DEFENSE ACQUISITION

Comanche Program Objectives Need to Be Revised to More Achievable Levels

June 7, 2001

Figure 1: Comparison of Comanche Pre-Production Aircraft Deliveries

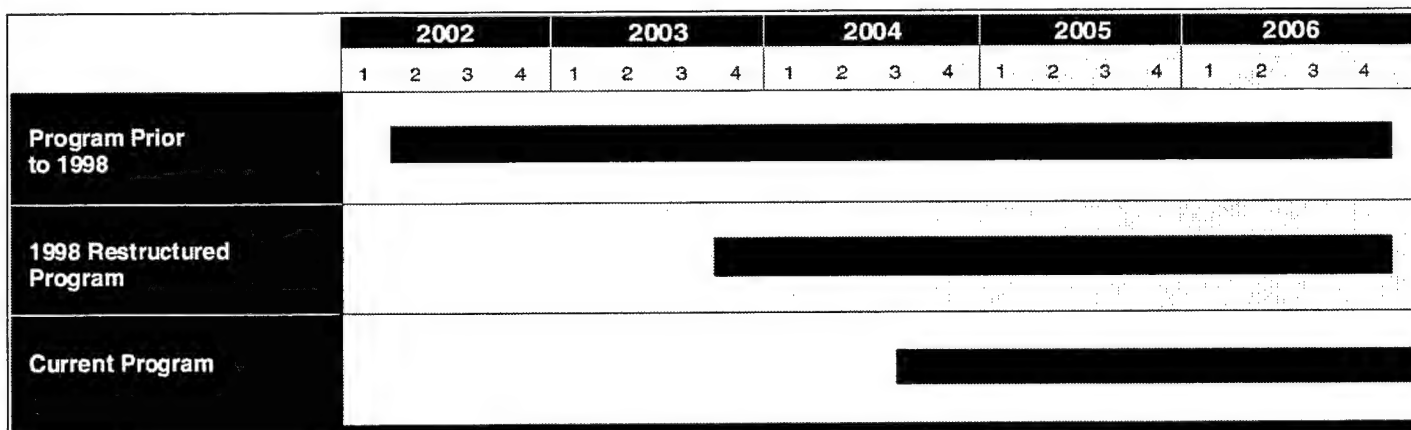
Since our last report, the first pre-production aircraft to be used for development testing is now scheduled for delivery in January 2004, adding an additional 3-month delay to the 19-month delay we reported in August 1999. As shown in figure 1 below, the delivery of pre-production Comanche aircraft has been delayed and, because the Army has retained the December 2006 full-rate production decision, the time available for testing, assessing, and correcting problems has been reduced.

Figure 2: Comanche Concurrent Flight Testing and Production

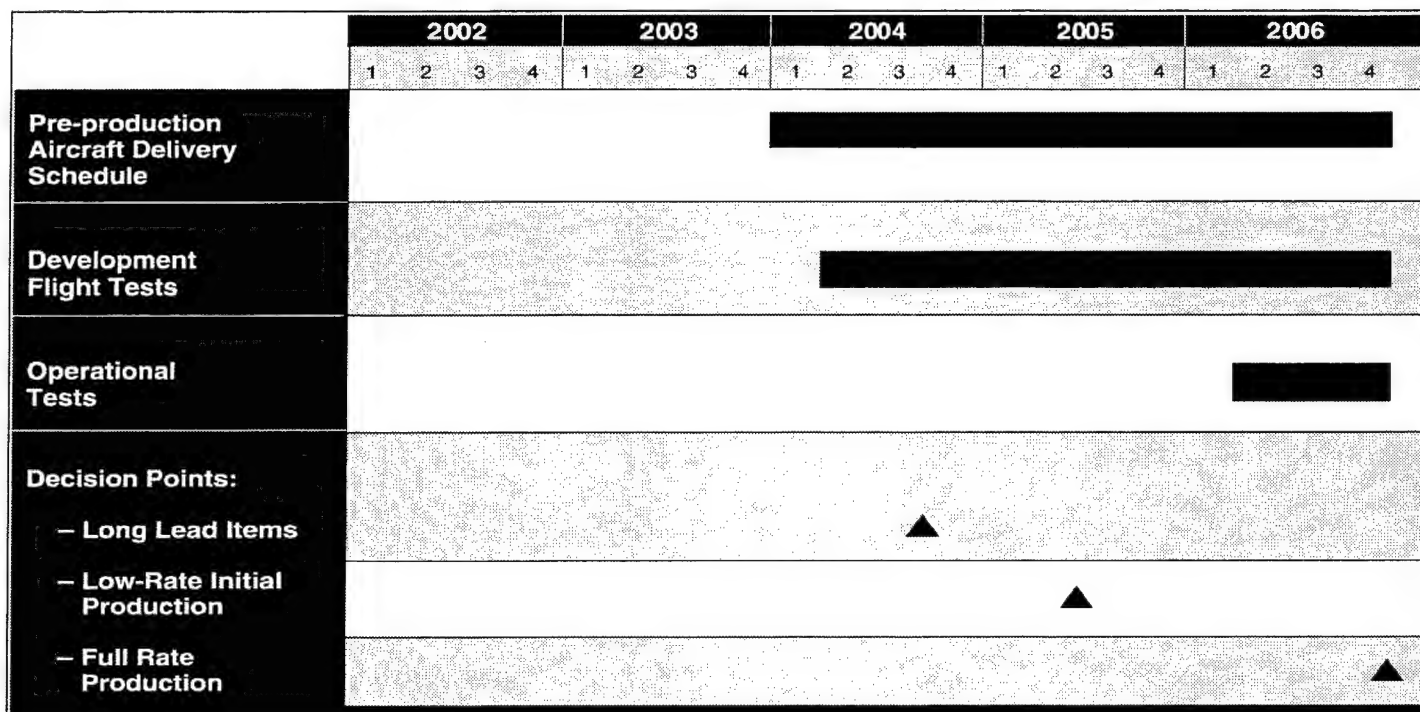
Many critical test events are now scheduled late in the development stages—during the low-rate initial production phase of the program—and, as shown in figure 2, many developmental and operational test events are scheduled to be conducted concurrently.

The combination of compressing the development schedule and undertaking developmental and operational testing activities concurrently leaves the Army with little room to accommodate any delays that may result from assessing, correcting, and retesting problems found during testing. In Comanche's case, several critical subsystems—to be included in the mission equipment package—may not be available until the development flight-testing is well underway. These subsystems are very complex, state-of-the-art systems that have not been demonstrated on a helicopter platform like Comanche. As testing proceeds, any problems found will need to be analyzed, fixed, and retested. However, with the ambitious test schedule, there may not be time available between test events to correct problems and prepare properly for the next event.
